Village of Warwick Village Board Work Session Agenda Tuesday, December 29, 2020 at 7:00 p.m.

1. Village View, LLC Subdivision Application for a Special Use Permit.

Re: Village View Estates, LLC Subdivision
Application for Special Use Permit

Excerpts from the Village View Cluster Subdivision SFEIS, dated 7/27/2020 showing Village Board comments and responses

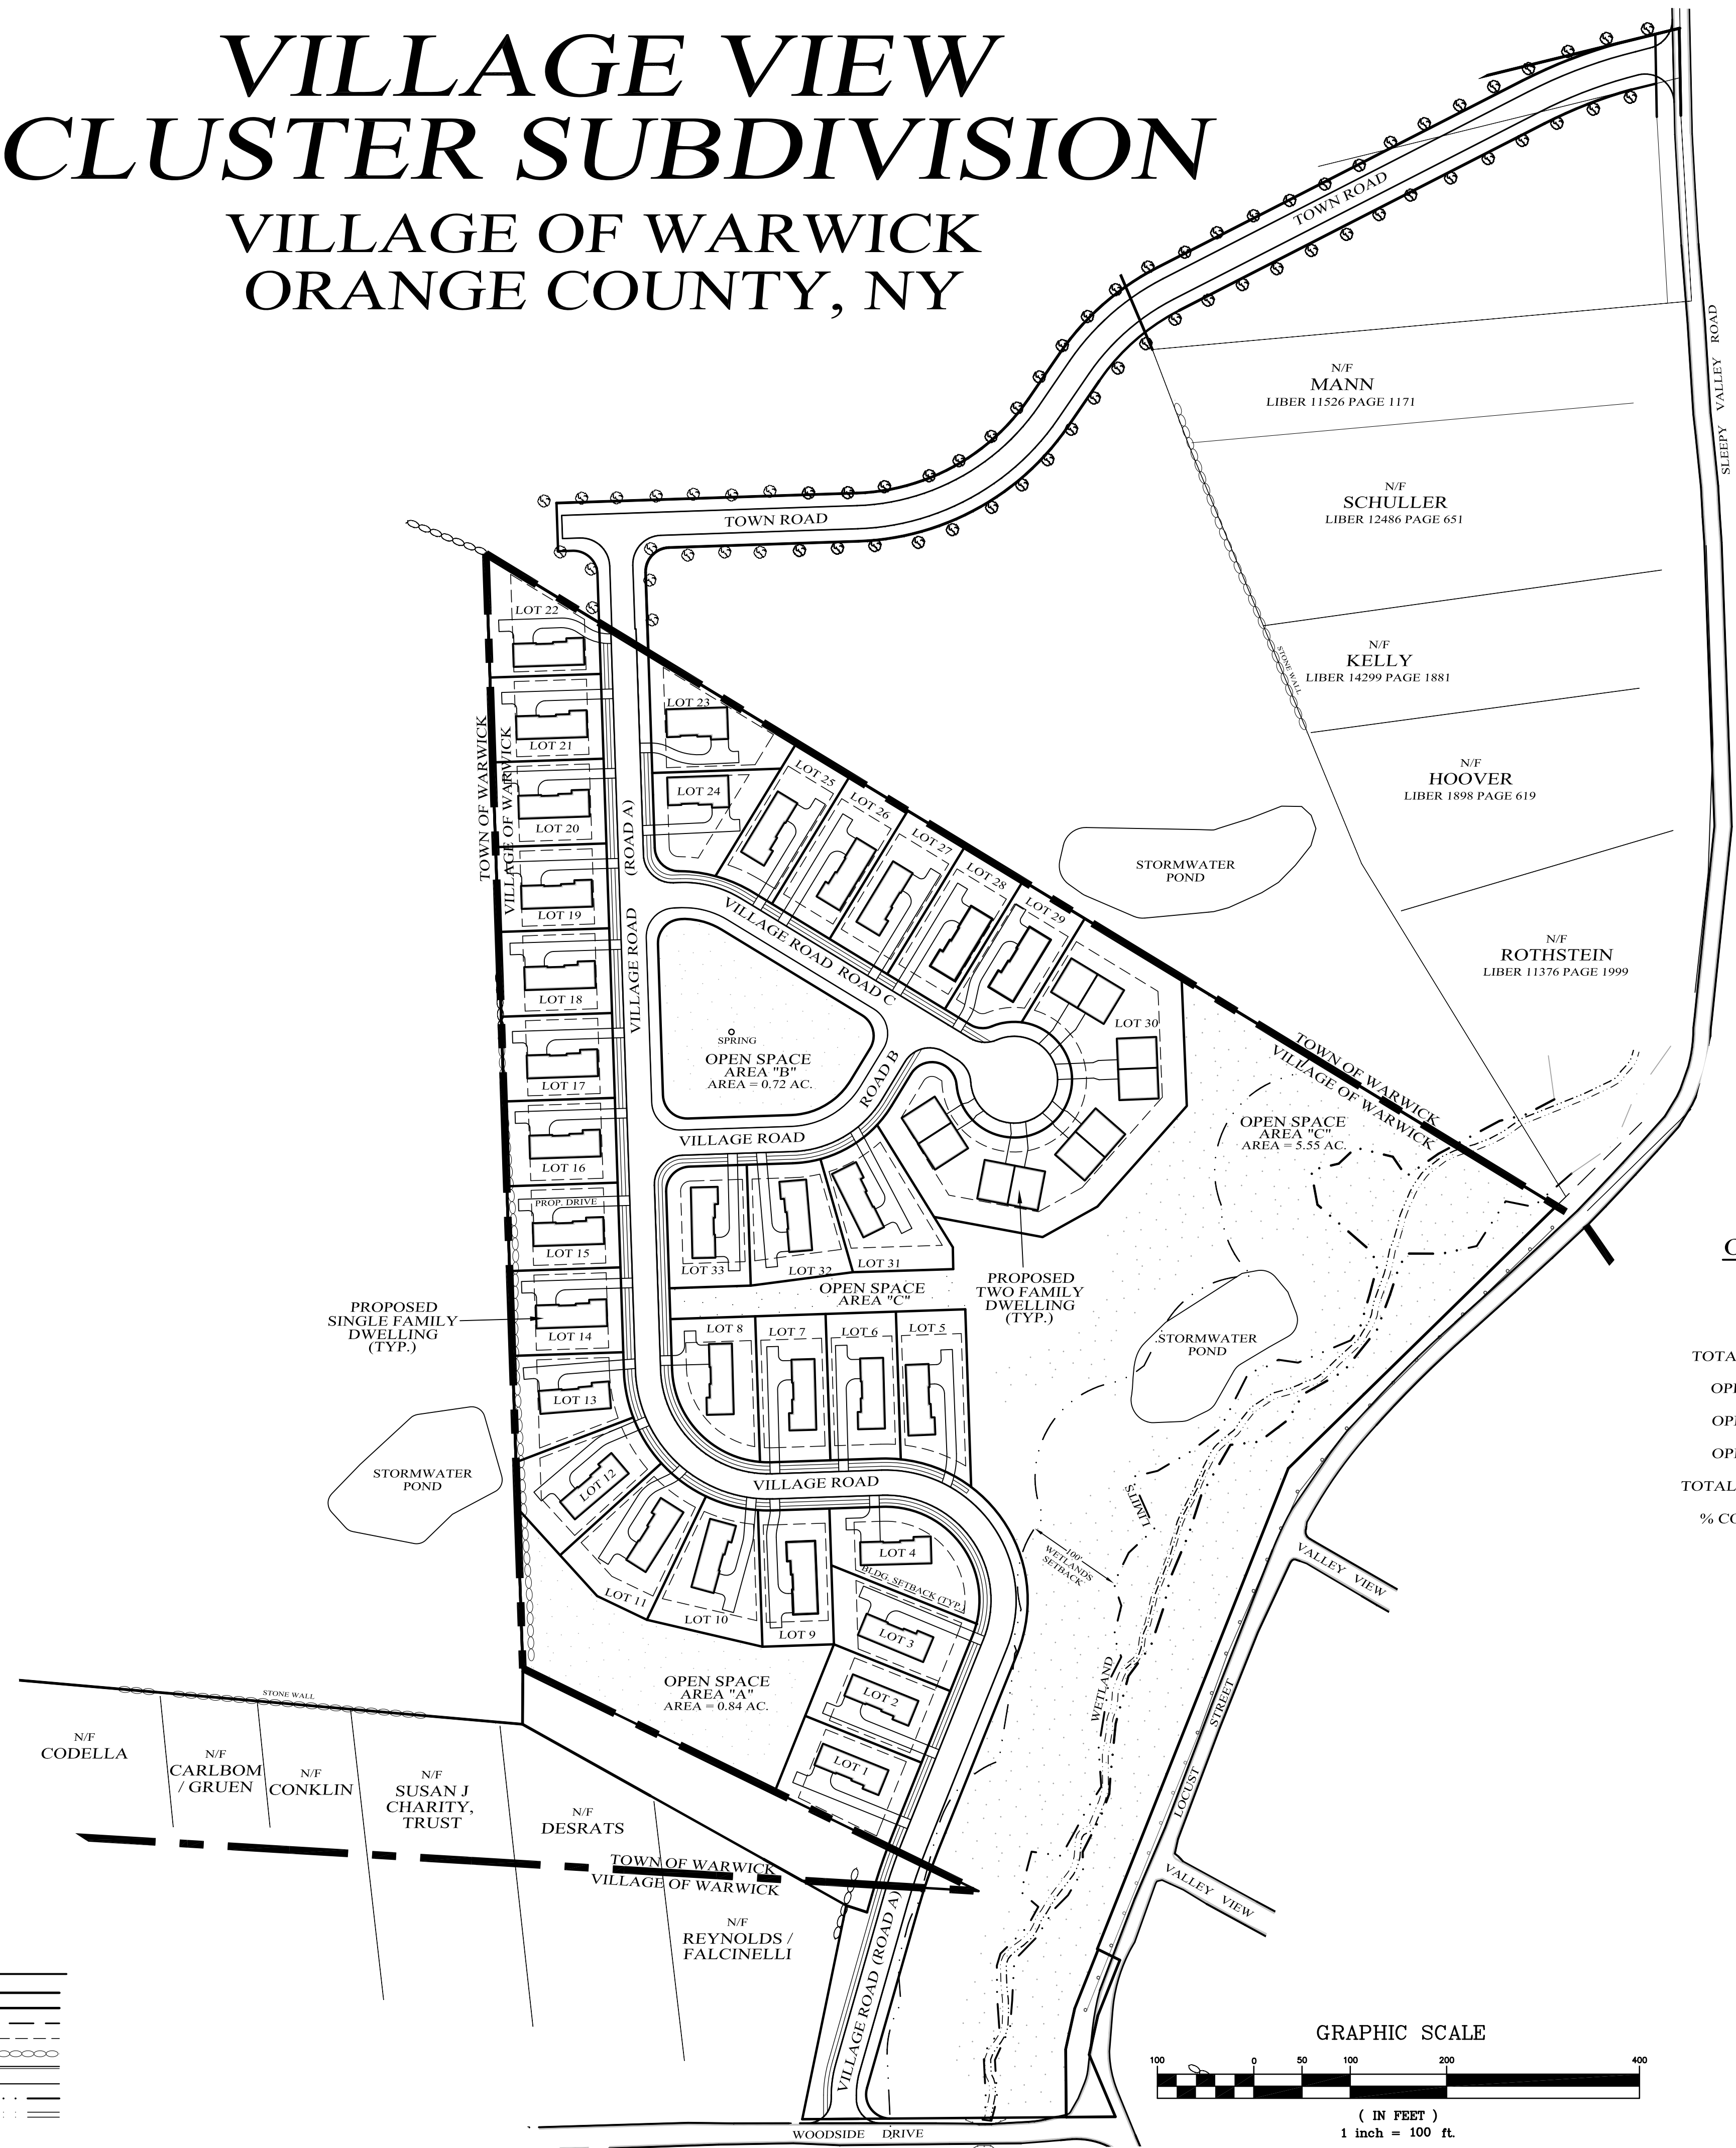
SEIS Comment Q.1.9: *Please give a history of why the entrance on Woodside was not originally considered in the twenty-eight (28) unit version and why was it changed? (VB-12)*

Response Q.1.9: The initial subdivision proposals for the Village View proposed an entrance to Woodside Drive as the main point of entry. In fact, the initial submittal had a single entrance to Woodside Drive as the only access point with an internally looped road and future stub to adjacent land owned by the project sponsor. Because the Village Code requires two points of access for subdivisions of 20 lots or more, a second access point was provided to Locust Street. Subsequent to multiple iterations of these initial plans which depict the main access point to Woodside Drive, at the request of the Village, the main entrance to Woodside Drive was relocated to Locust Street. Doing so resulted in a second stream crossing and additional wetland impact. The relocation of the proposed Woodside Drive entrance to Locust Street was not due to any environmental constraints as some have claimed. In fact, the change resulted in added environmental impact. The relocation was also not due to traffic safety as the change resulted in the entirety of eastbound project traffic to travel through the Woodside Drive/Locust Street intersection. The change also resulted in the need to make significant improvements to Locust Street in order to improve sight distance.

The RSA that is the subject of this FEIS is proposed as a clustered type subdivision. One of the main objectives of clustering the development is to protect Primary and Secondary Conservation areas as permanent open space. The most significant Primary Conservation Area within the Village View site is the stream and associated wetlands. By returning the proposed entrance to Woodside Drive, and providing a second means of access through the Town property to Sleepy Valley Road, impacts to the stream and wetland are completely eliminated. The Woodside Drive entrance location also offers significantly improved safety with regard to vehicular movements due to the availability of sight distances to the north all the way to the Woodside/Locust intersection, and to the south for a distance exceeding 500 feet. Finally, the Woodside drive location allows for more gentle grading and less cut and fill of the proposed road as compared to the two stream crossings to Locust Street which require substantial fill sections.
